**ARCHITECTURAL REVIEW BOARD
MUNICIPAL PLANNING COMMISSION
-AGENDA-
Thursday, October 13, 2016 at 7:00 P.M.**

MEMORANDUM

SUBJECT: Staff Memo for the Meeting of October 13, 2016

THE VILLAGE AT WORTHINGTON SQUARE

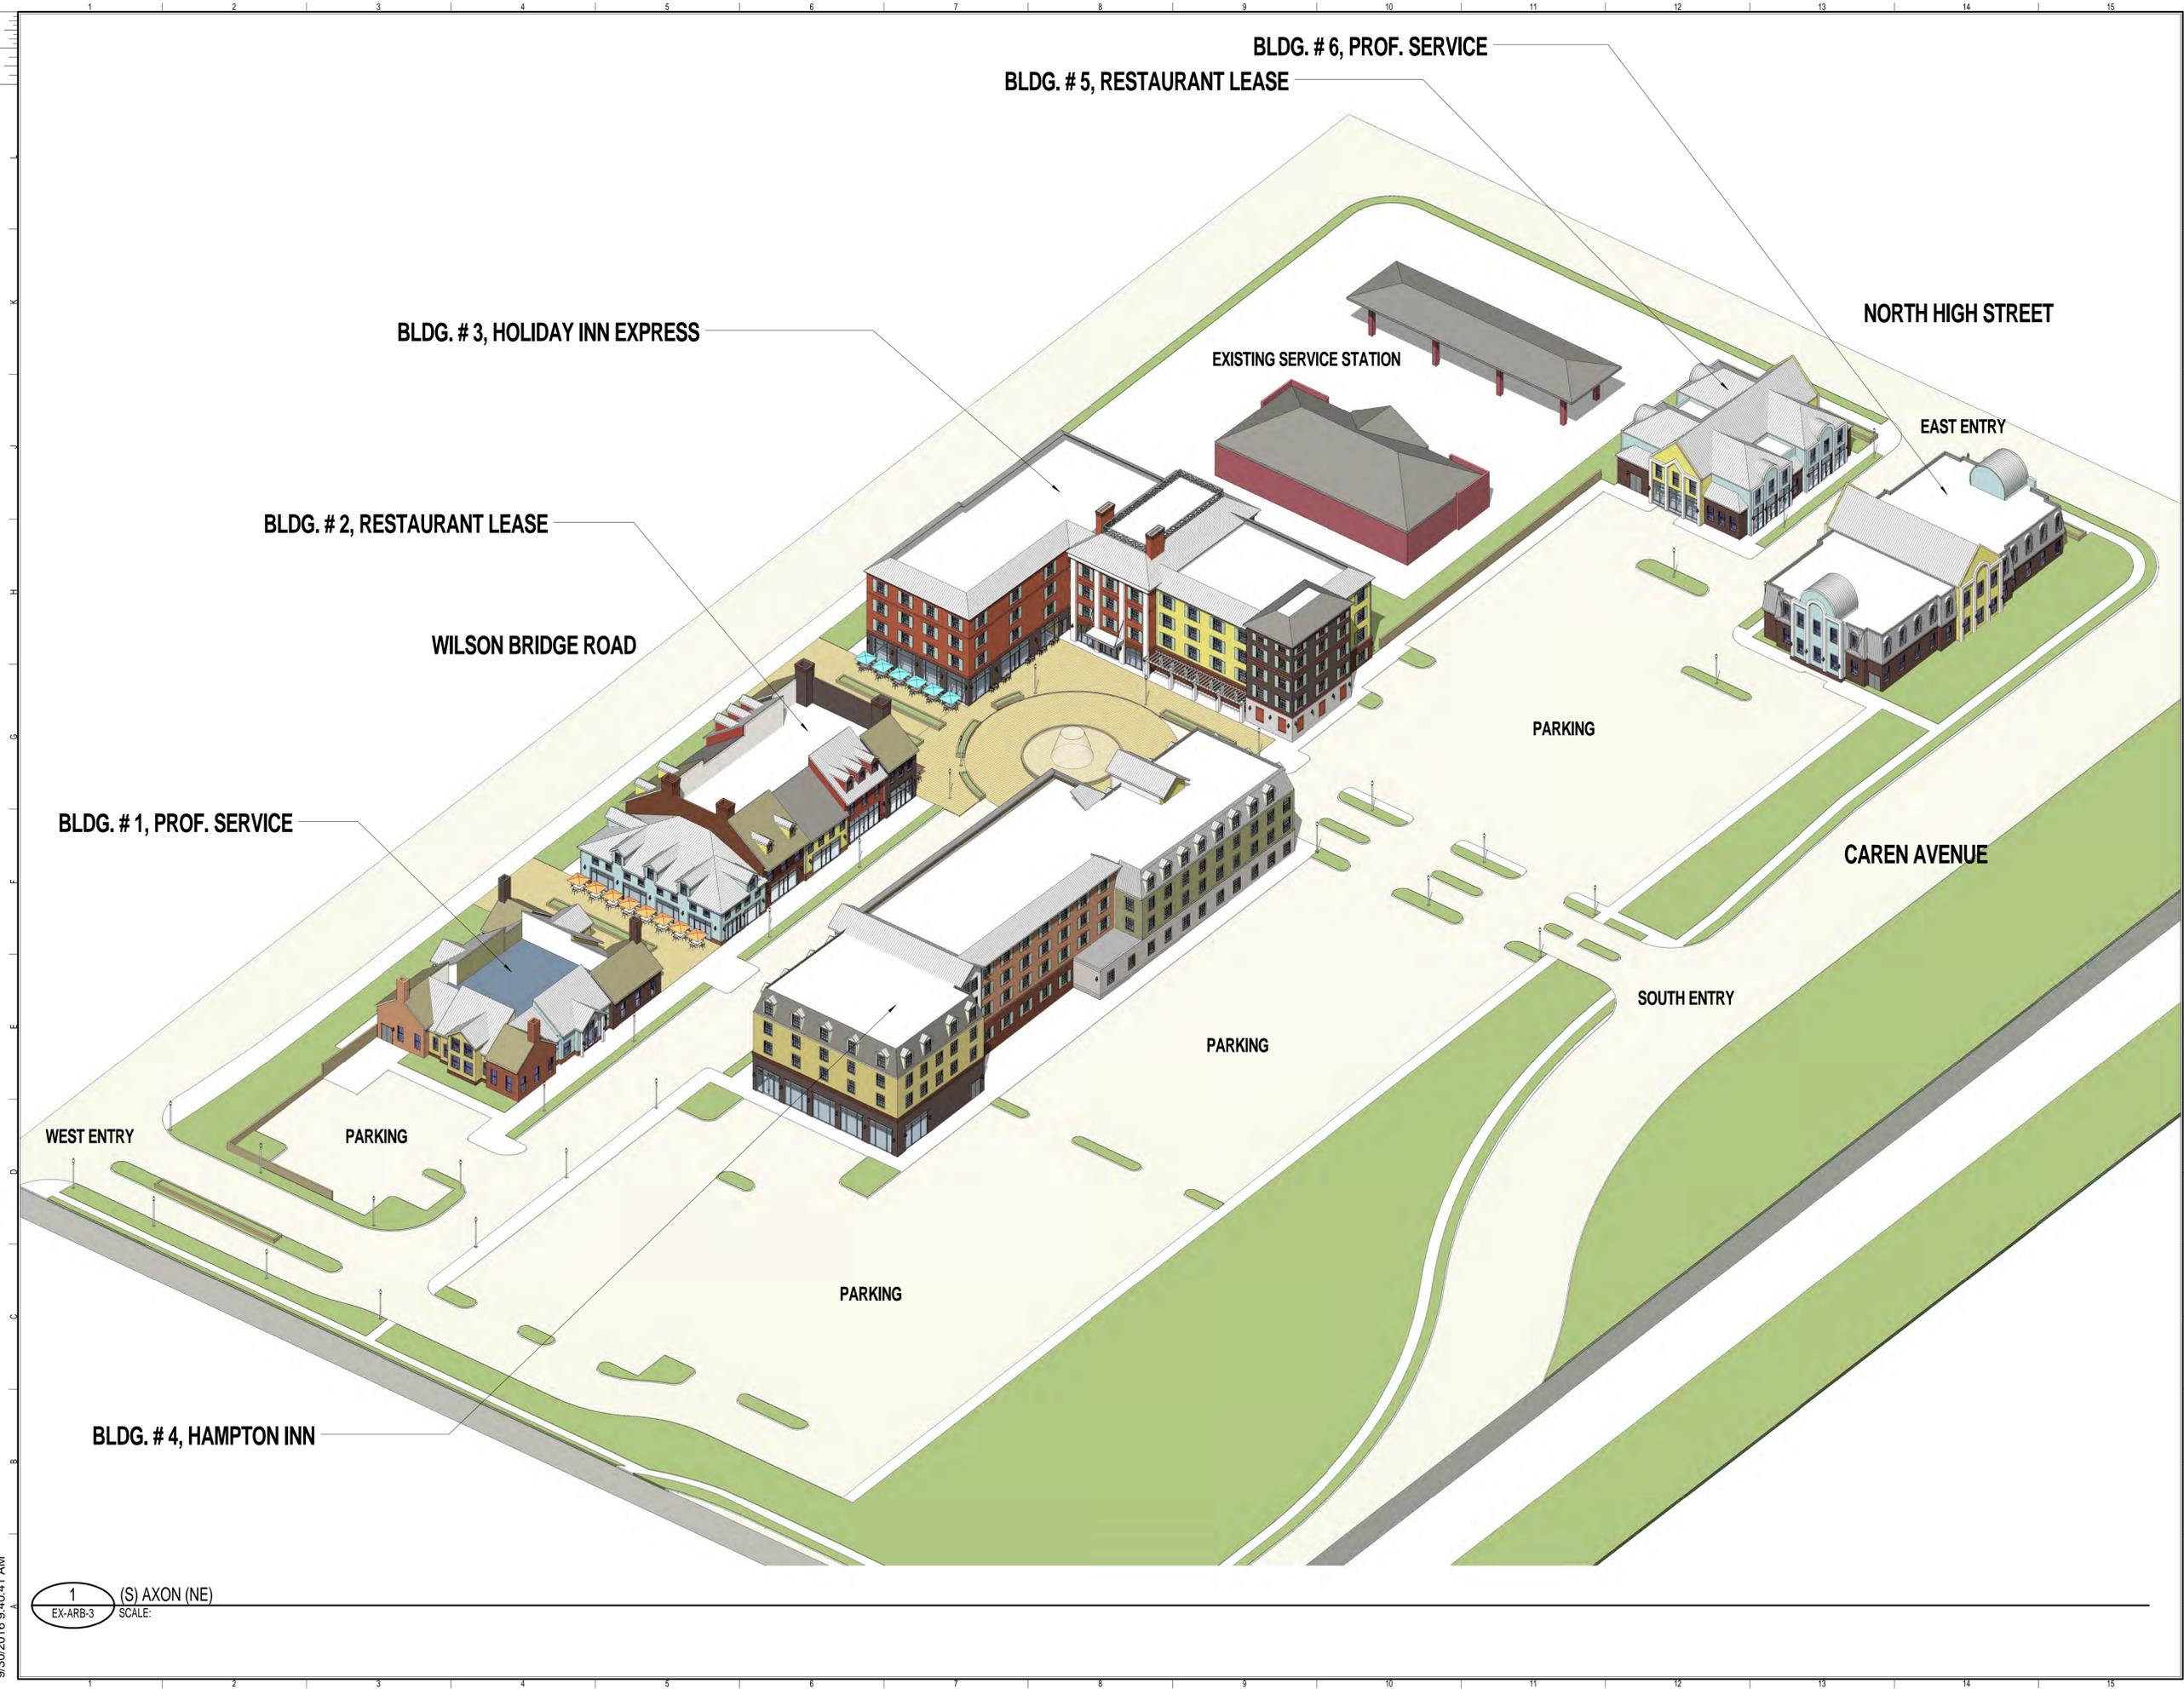
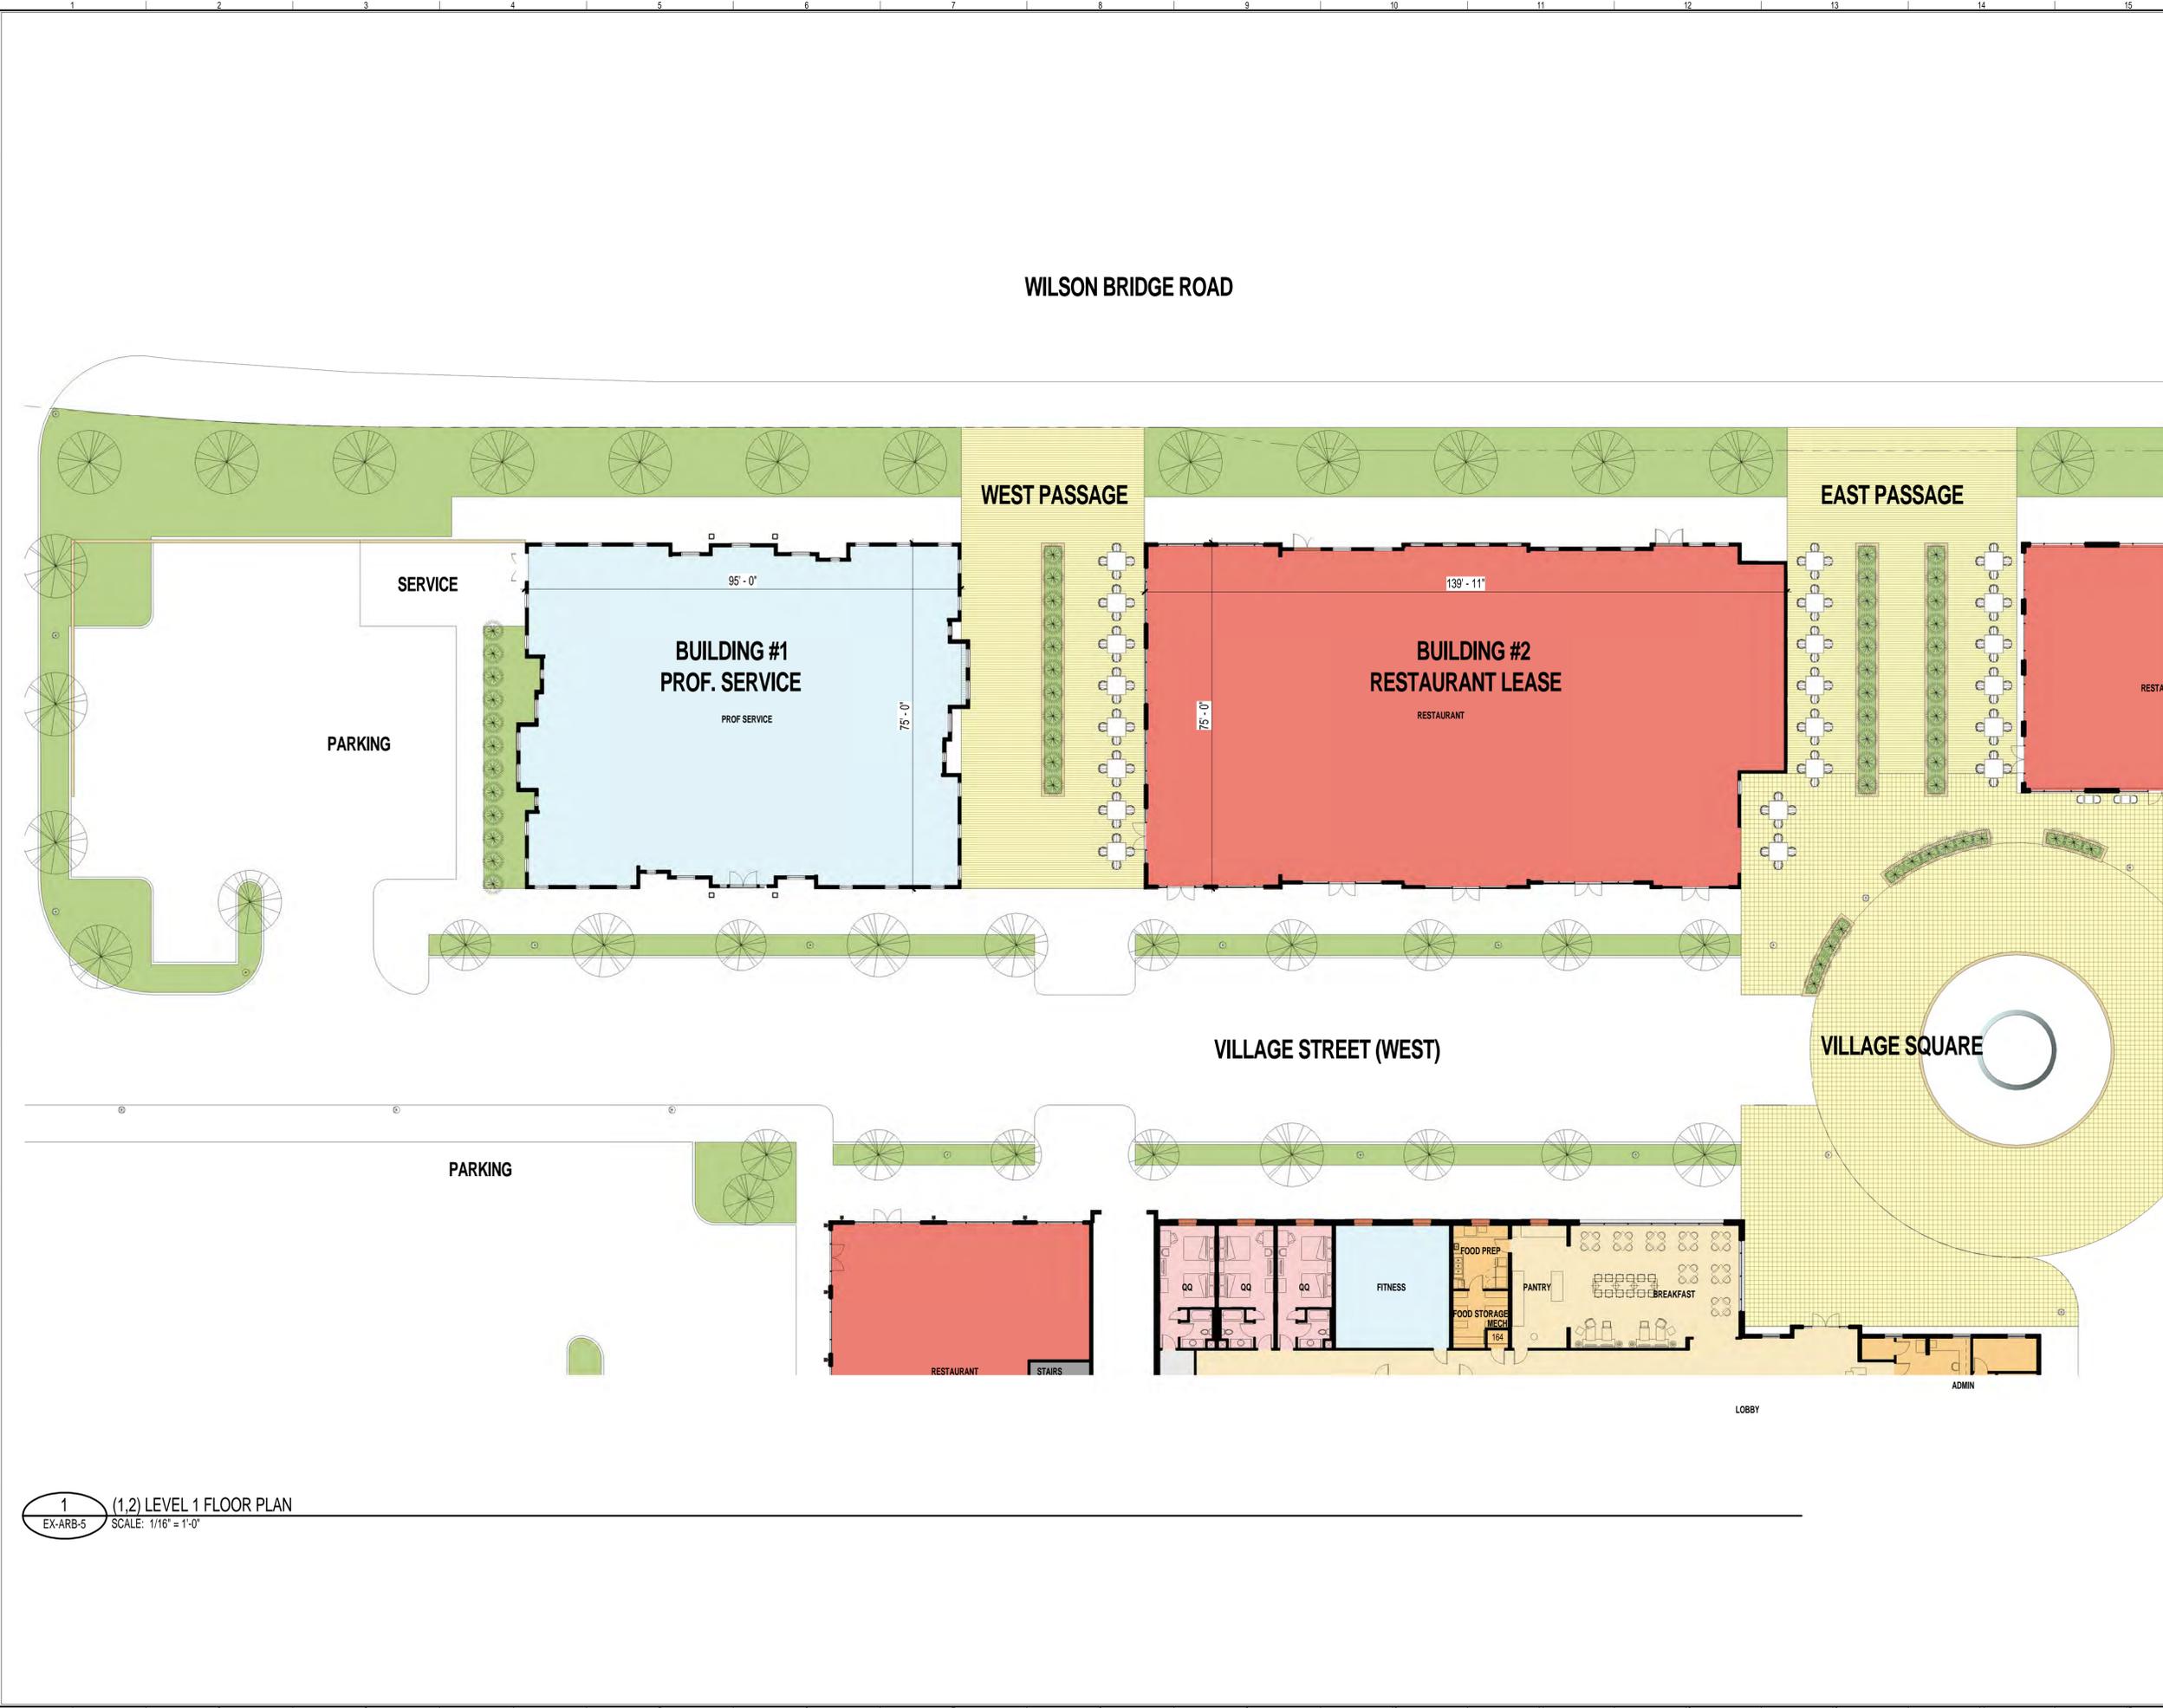
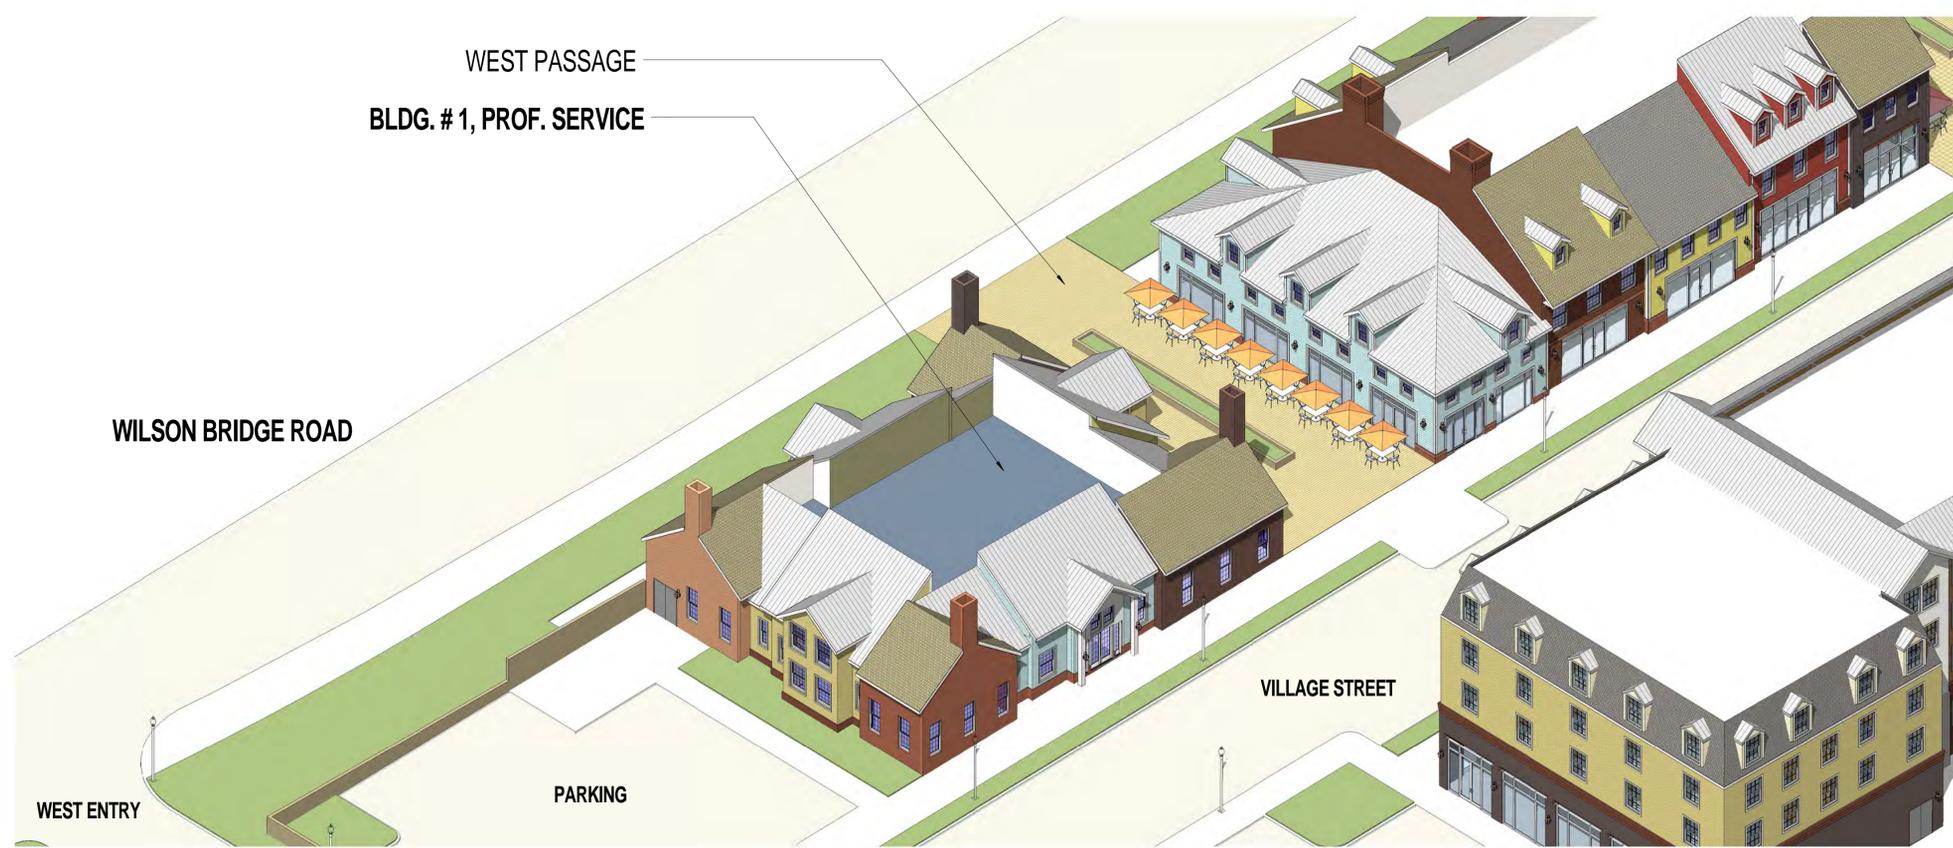
- The buildings are all shown as having four-sided architecture that is described as Colonial style. A variety of building heights, roof forms, materials and details are proposed across the site. A sheet with a large variety of proposed materials is included in the packet. The renderings do not necessarily reflect the exact color and

- A simpler mix of materials and colors may be warranted. The extensive use of lap siding, bright colors and metal roofing, especially on the larger buildings, does not seem appropriate. A simpler more subtle use of colors could provide a development that fits in better with Worthington.

4. Staff is recommending *tabling* of this application after discussion, to allow the applicant to make modifications and add detail based on the guidelines and any recommendations made at the meeting.
